ALLEN B. DU MONT LABORATORIES, INC.

TELESET SERVICE BULLETIN

RE-ORGANIZATION OF SERVICE NOTES

ION TRAP MAGNET ADJUSTMENT

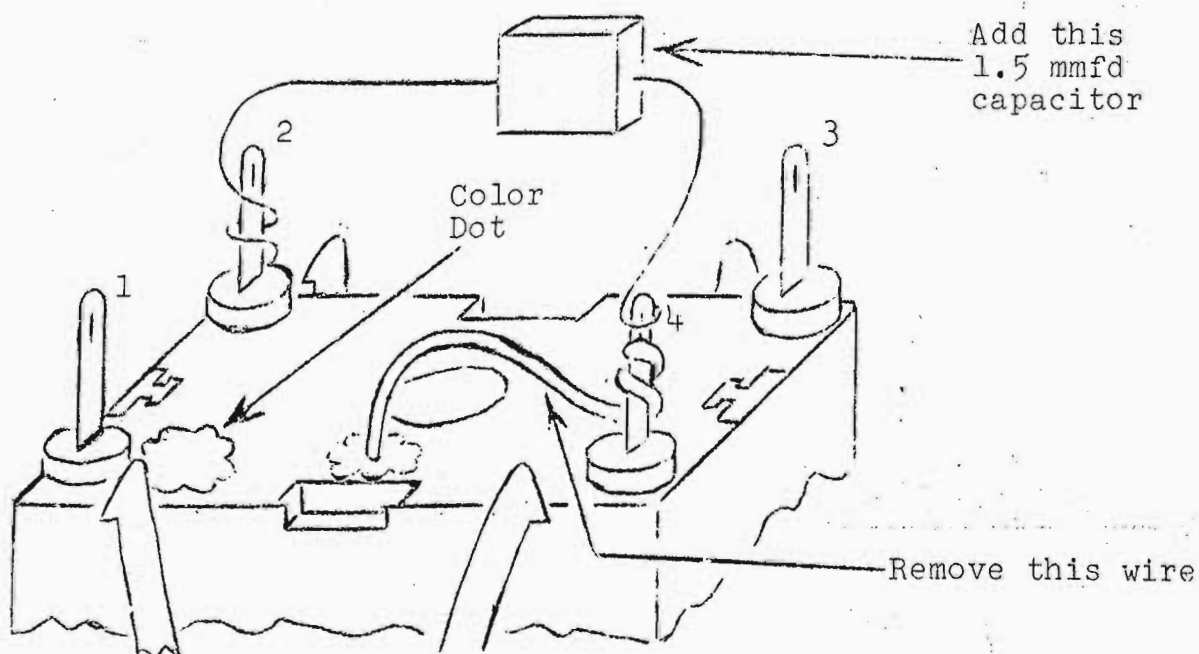
You have probably noticed that on current Telesets it is necessary to place the ion trap magnet over the base of the cathode-ray tube in order to get the correct adjustment for maximum brightness.

Although contrary to the installation instructions and the instructions on pages G-4 and G-5, this new position is the result of a slight change in the design of the electron gun in the cathode-ray tube. Due to this design change, the magnetic field necessary for proper beam bending is decreased. Therefore, the position of the magnet indicates that it is too strong to be placed on the glass neck end, therefore, must be placed back over the base. Under no conditions should this magnet be placed next to the focus coil.

Rewiring for 6CB6 Substitution
In Video Amplifier Stage

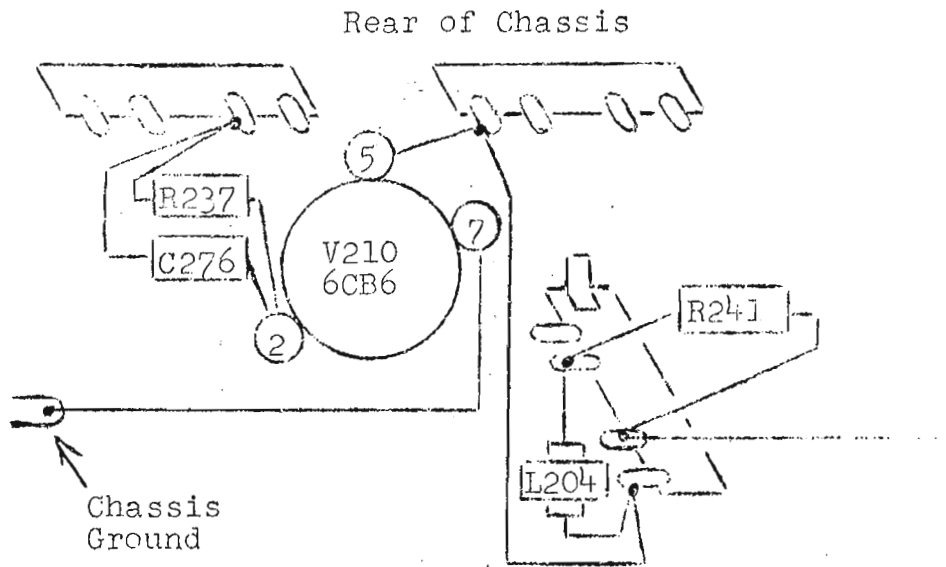
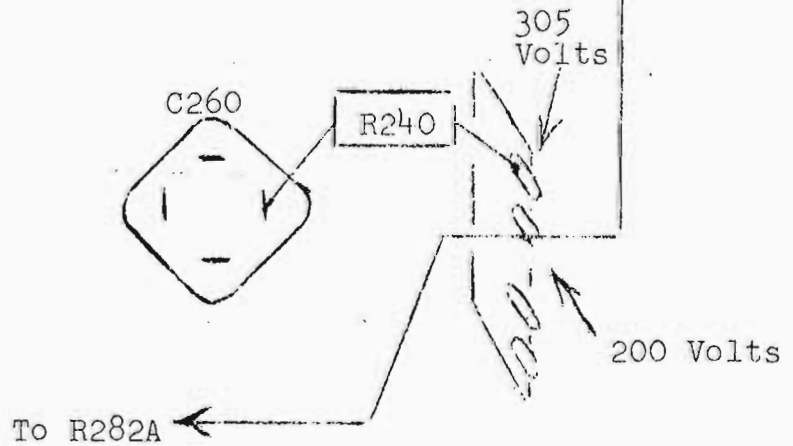
(4813) 3. A 6CE6 may be substituted for the 6AH6 video amplifier, V210, in the RA-112A and RA-113 without any component changes but with a simple wiring change. Pins 2 and 7 must be interchanged and the plate circuit must be tied to a 200 volt point rather than 305 volts, as shown in the sketch on the following page, G-14B.

This wire is removed from 305 volts and reconnected to 200 volts.

Present Wiring of 6AH6

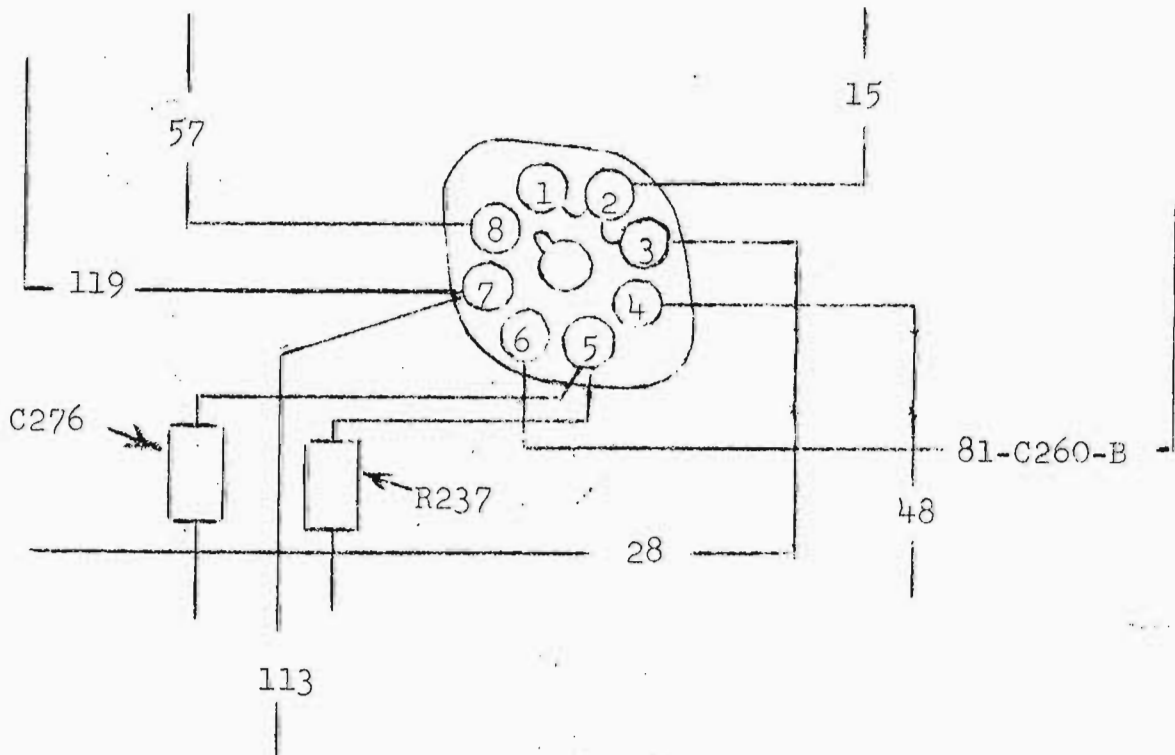
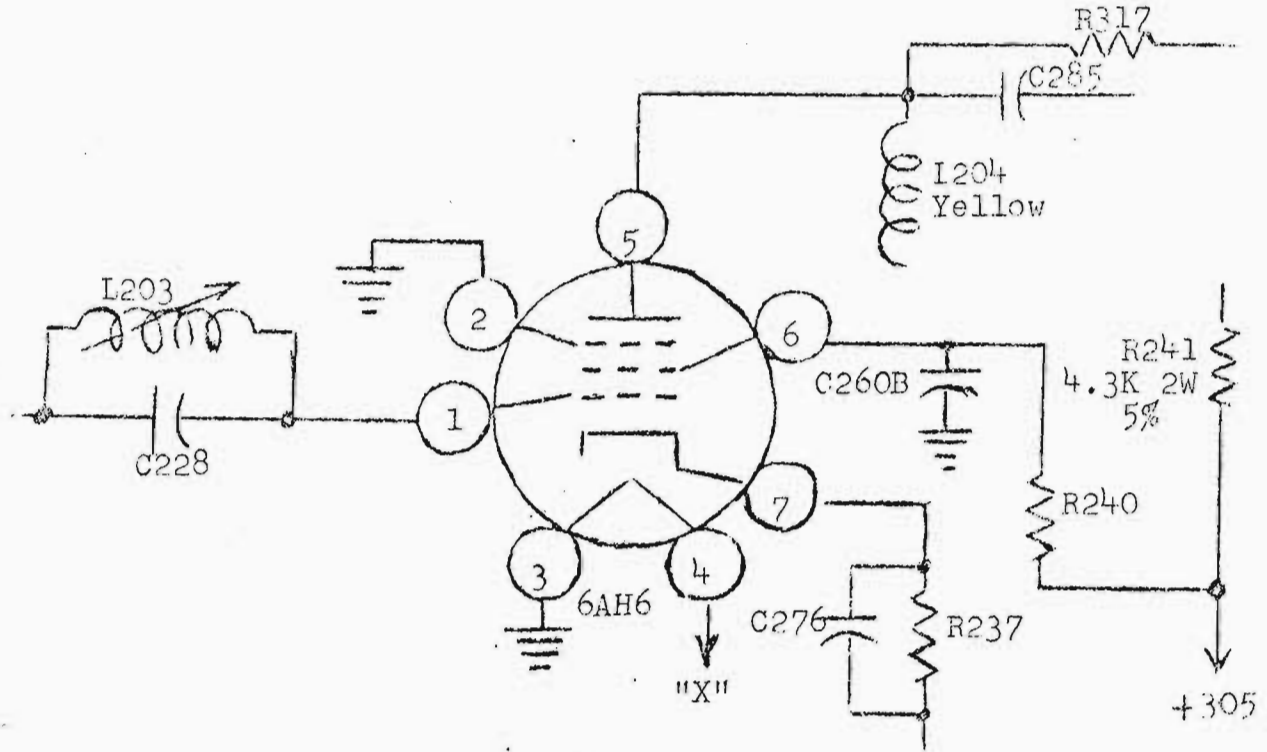
(4789) 5. The type 6AC7 may be substituted for the 6AH6 video amplifier in the RA-112A and RA-113 Telesets. This tube is not a direct substitute and several items will have to be changed. These are as follows:

The wiring and circuit changes are shown on this page, G-14C and the following page, G-14D.
